Appendix D

Review of "Technical Basis for Gas Transport to the Pump Suction," Fauske & Associates, LLC, FAI/09-130, ML110480451 and ML110480452 (Non-Proprietary), ML110480456 (Proprietary), December, 2010

D-1 Introduction and Summary

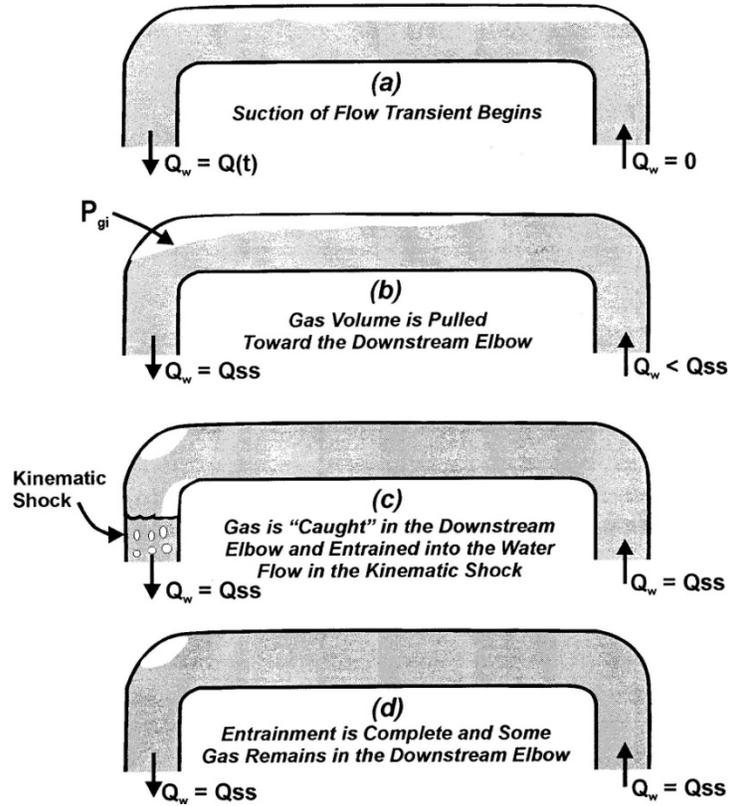
Note that some ECCS suction connections are from the side or top of the horizontal header so that behavior differs from that associated with the figure. This difference does not affect the Fauske conclusions when it is correctly addressed.

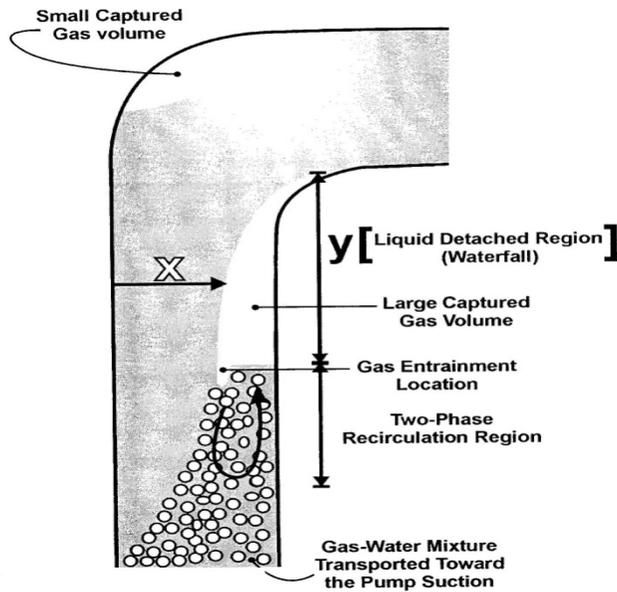
An essential feature of the shock is entrainment of air by the waterfall as the water plunges into the top of the water column. Fauske concludes that "as long as the downcomer is sufficiently tall to establish the kinematic flow pattern for the conditions of interest, the gas void fraction that will be transported to the pumps, will be in a bubbly flow configuration." This is correct with respect to flow from the bottom of the downcomer as long conditions downstream of the downcomer do not affect the bubbly flow configuration, conditions that are not substantiated by test data.

1. "As long as the downcomer is sufficiently tall to establish the kinematic flow pattern for the conditions of interest, the gas void fraction that will be transported to the pumps, will be in a bubbly flow configuration." This does not address behavior from the downward end of the vertical pipe to the pump suction.

2. The behavior at large N_{FR} where a kinematic shock occurs in the upper horizontal pipe with a slug of gas in front of the shock is not mentioned. This could occur with the initial gas volume small enough that the kinematic shock would not develop in the upper part of the downcomer if N_{FR} were smaller, or at a large enough N_{FR} for the gas to pass through the elbow and the downcomer as a slug. The potential concern is that this slug continues through the piping and reaches the pump. However, if this occurs, the kinematic shock will not develop in the upper downcomer and the method will not be applicable.

A schematic of the Palo Verde test is shown in the following sketch that was provided as Figure B-1:

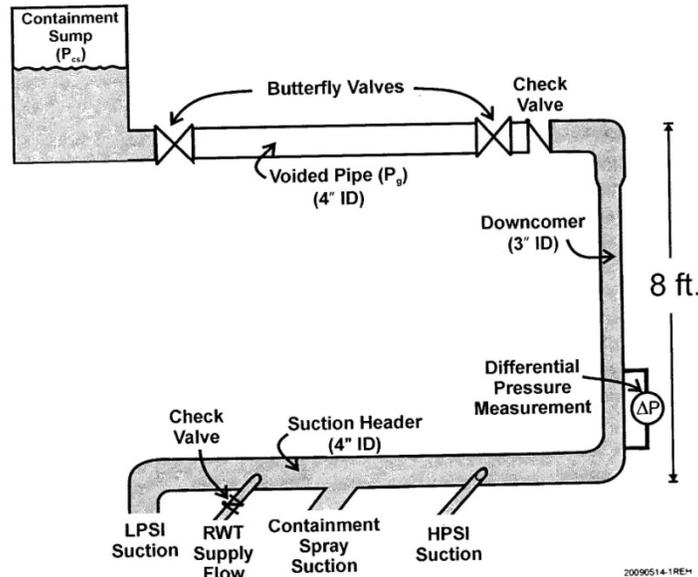
The difference in horizontal and vertical downcomer diameters is stated to have been "done to ensure the downward water velocity exceeded the bubbly rise velocity as would be the case for the plant suction piping." This was achieved at the expense of distorting behavior in the vicinity of the ends of the horizontal pipes. We consider failure to address phenomena in the lower horizontal pipe to be an important weakness in both the test and its application to modeling of plant behavior.

No length information was provided for the 4 inch downcomer before the reducer. We note this will perturb the flow behavior and the kinematic shock in the upper downcomer but the downcomer length appears to be long enough that bubble behavior was fully established by the time bubbles reached the bottom of the downcomer.

N_{FR} was used when discussing results but the report did not clearly indicate whether it was calculated for the 4 inch or the 3 inch pipe. It did state that for $N_{FR} = 0.6$, the velocity in the 4 inch pipe was 2 ft/sec and in the 3 inch pipe it was 3.6 ft/sec. Using these velocities, we calculate $N_{FR} = 0.61$ and 1.27 for the 4 and 3 inch pipes, respectively. The difference is a factor of two, in agreement with the report description and an important difference when considering results within the downcomer and at both ends where the diameter of both horizontal pipes is 4 inches. This probably means that bubbles will be more likely to concentrate at the top of the 4 inch upper horizontal pipe immediately downstream of the elbow than would be the case with a 4 inch diameter downcomer and it will be more difficult for bubbles to re-enter the bottom of the downcomer from the lower horizontal pipe than would be the case for 4 inch pipe throughout.
